This Service Information bulletin supersedes SI M17 08 12 dated **October 2012**.

Service Action: Retrofit of the Engine Coolant Temperature Sensor

R55

All with **automatic transmission** and either the N16 or N18 engine

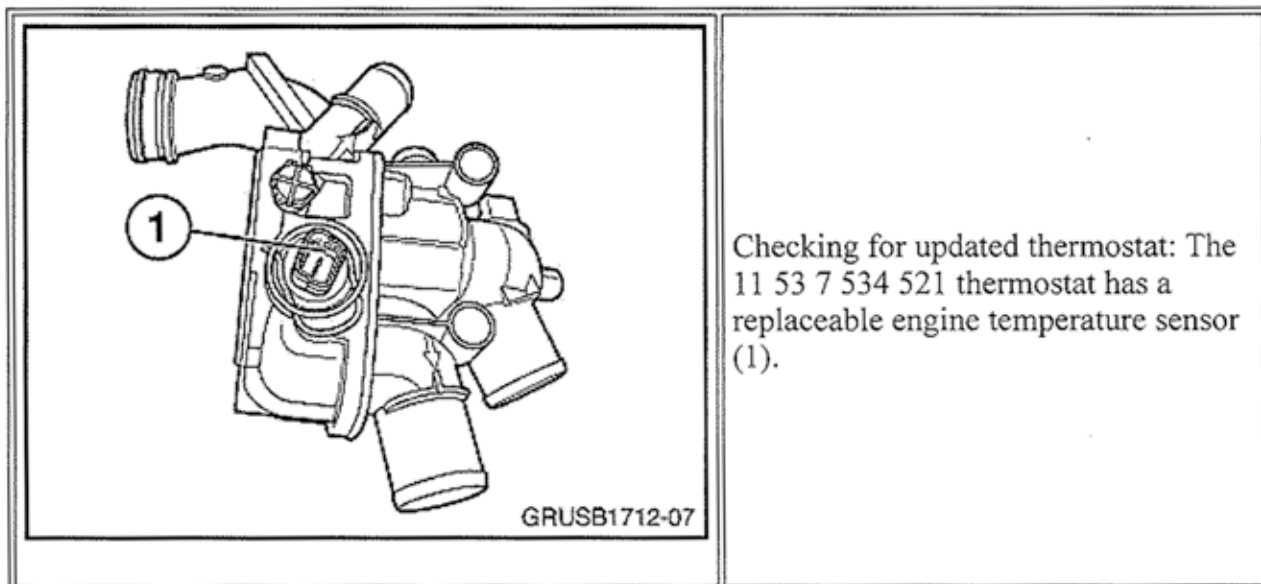
NEW There are two approved repair procedures, depending on parts availability. Both procedures involve installing an engine temperature sensor remotely and wiring this new sensor into the vehicle's engine harness. Only perform one of these recommended procedures when completing this Service Action.

NEW **Procedure One** requires the replacement of the upper coolant hose with a modified hose that

houses a new engine temperature sensor. An adapter harness needs to be fitted to the car to utilize this new sensor.

NEW Procedure Two requires the installation of a new engine temperature sensor, with integrated wire harness, installed in place of the thermostat bleeder screw.

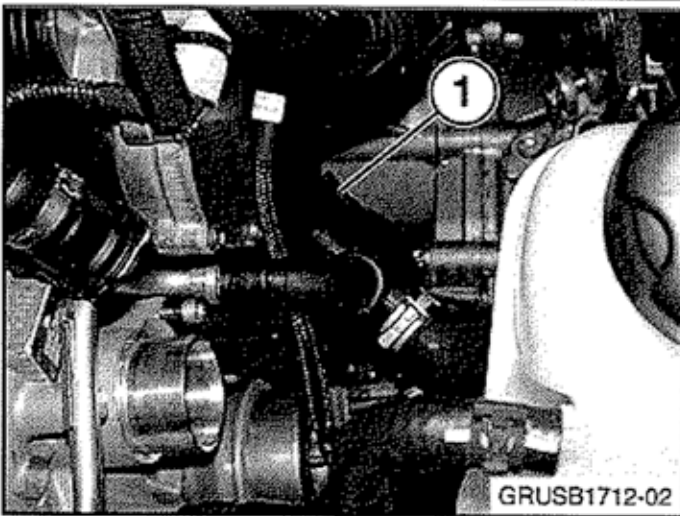
Remove the coolant hose (1). This hose will not be reused.

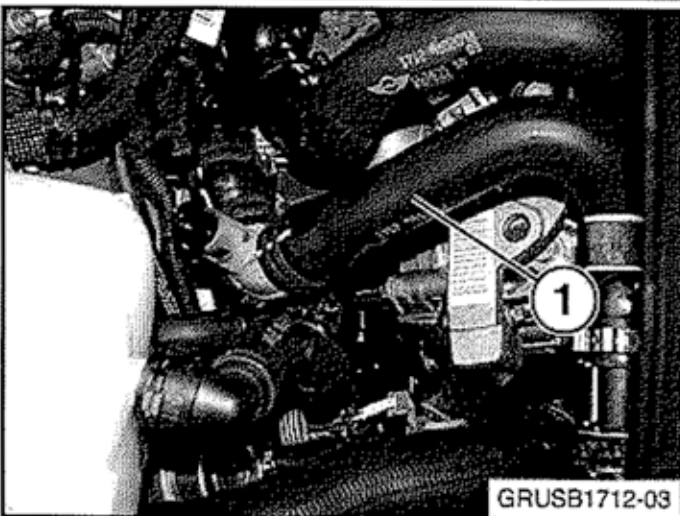
N18 engine only! Install spacer P/N 64 53 7 578 707 (1) on the coolant line as shown.

Note: The spacer needs to stay in this position when installing coolant hose P/N 17 12 9 811 352 (next step).

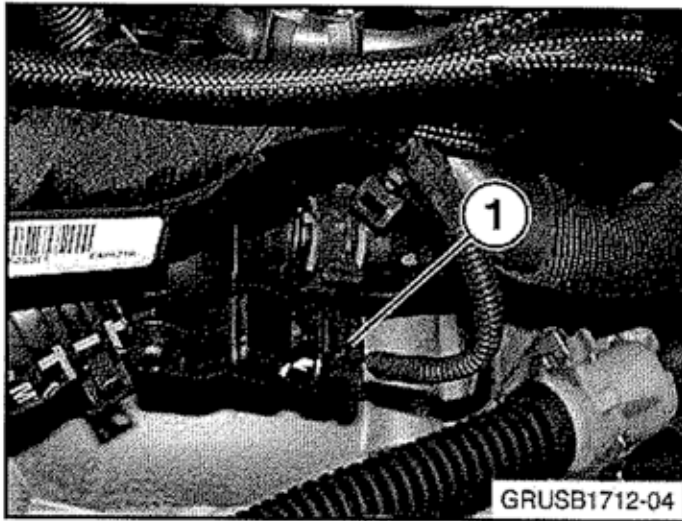
Install the new coolant hose with sensor P/N 17 12 9 811 352 (1).

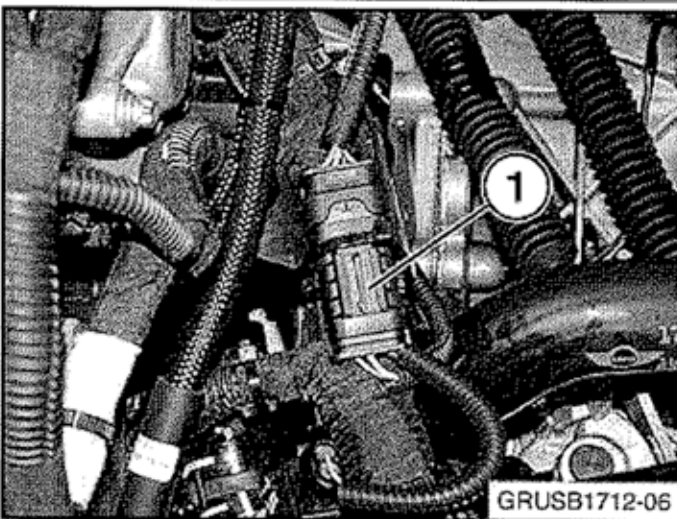
Plug connector X6279 into the 4-pin male connector (1) of adapter harness P/N12 51 7 647 200. Insert the 4-pin female connector (2) of the adapter harness into the engine thermostat. Plug the 2-pin female connector (3) from the adapter harness into the engine temperature sensor of hose P/N 17 12 9 811 352.

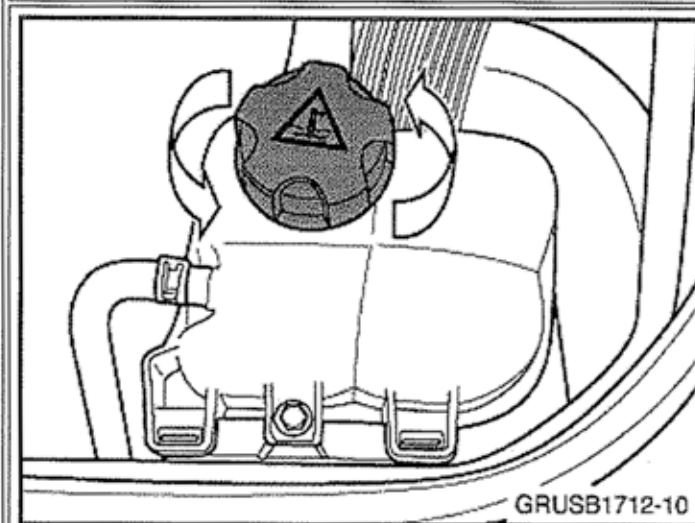
The improved sensor (P/N 13 62 8 603 908) includes the temperature probe (1) and insulating sleeve (2), a two-pin female connector (3) for the map thermostat, and a four-pin connector (4) for the engine harness.

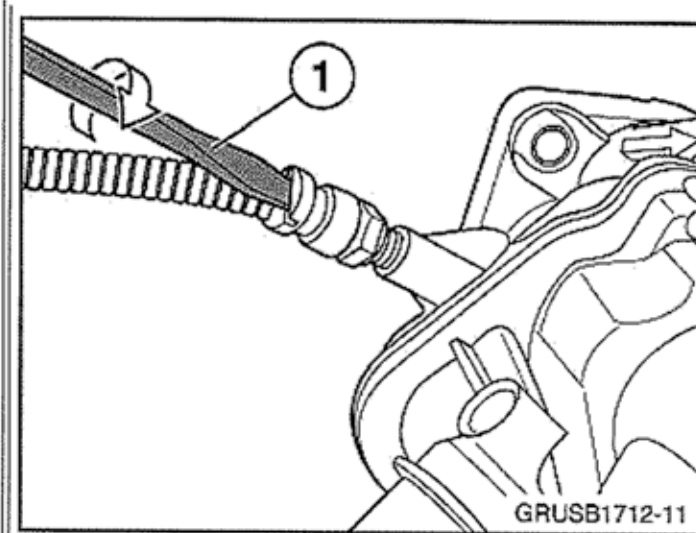
Remove the bleeder screw (1) from the thermostat. This screw will not be reused.

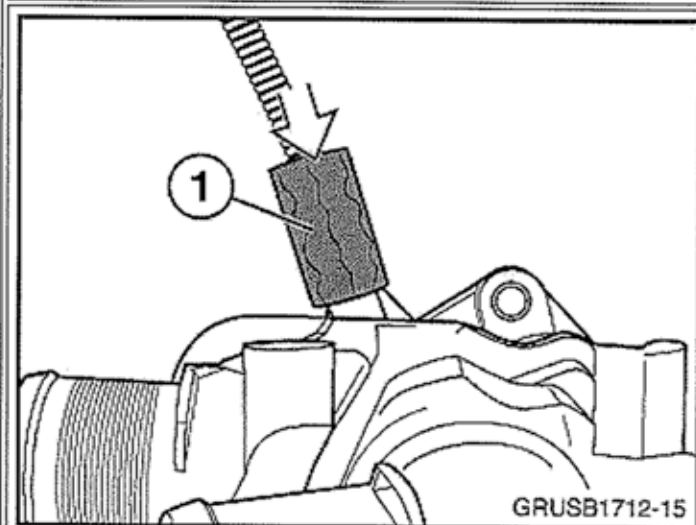
The back of the temperature sensor is slotted to accept a bladed screwdriver (1). Install the sensor into the bleeder screw hole, and torque to 2Nm.

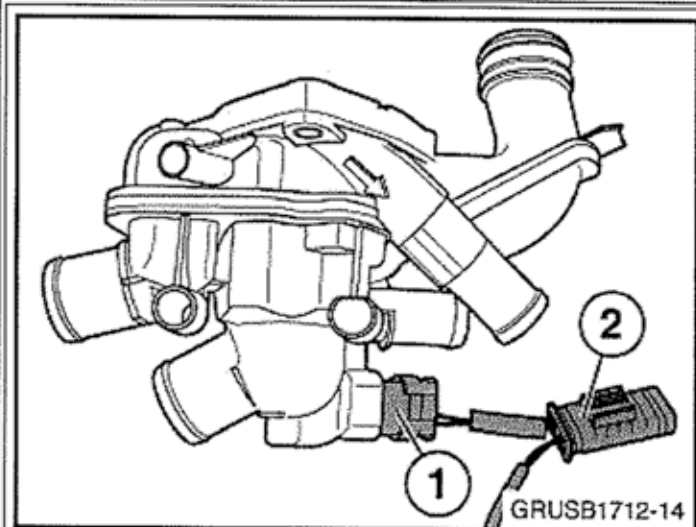
Slide insulating sleeve (1) onto the temperature sensor. The sleeve must completely cover the sensor.

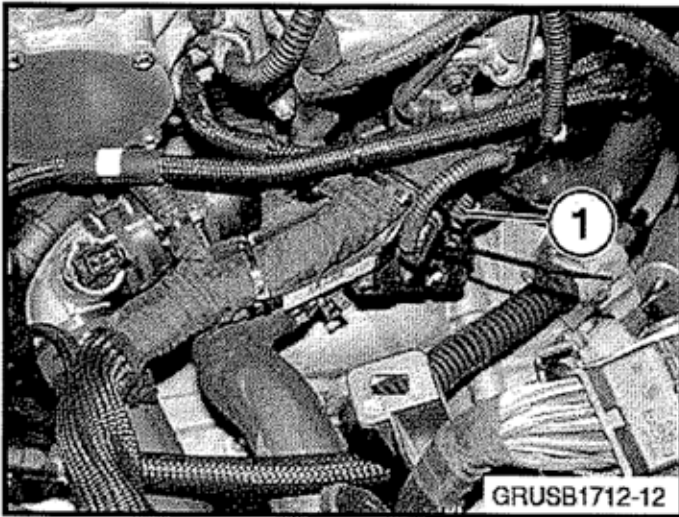
Install the two-pin female connector (1) into the thermostat and the four-pin male connector (2) into the engine wiring harness.
